Addendum No. 4

**To Offerors: Request for Proposals
Abatement and Demolition Services
BVRI-002 – 1601 E Lombard Street**

Questions and Answers No.2 (QAA2)

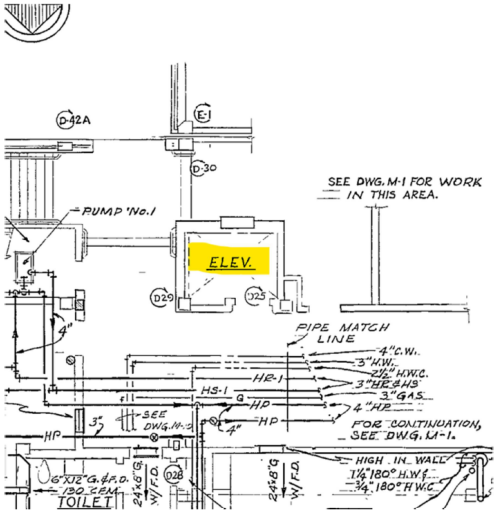
Question	Answer
22.	<p>057-1959-1A01.TIFF DRAWING A-1: Sector D shows sheet piling within Sector D for right of way protection. Please clarify action.</p> 	<p>Offerors are to assume for sheet piling to remain.</p>
23.	<p>057-1959-1A01.TIFF DRAWING A-1/ A-8: Sector G show information regarding oil tank venting manholes, indicating that there are below grade tanks within the building or below ground. Manholes do exist as shown below. Please clarify action.</p>  	<p>Please see answer to No. 15 of this QAA2.</p>
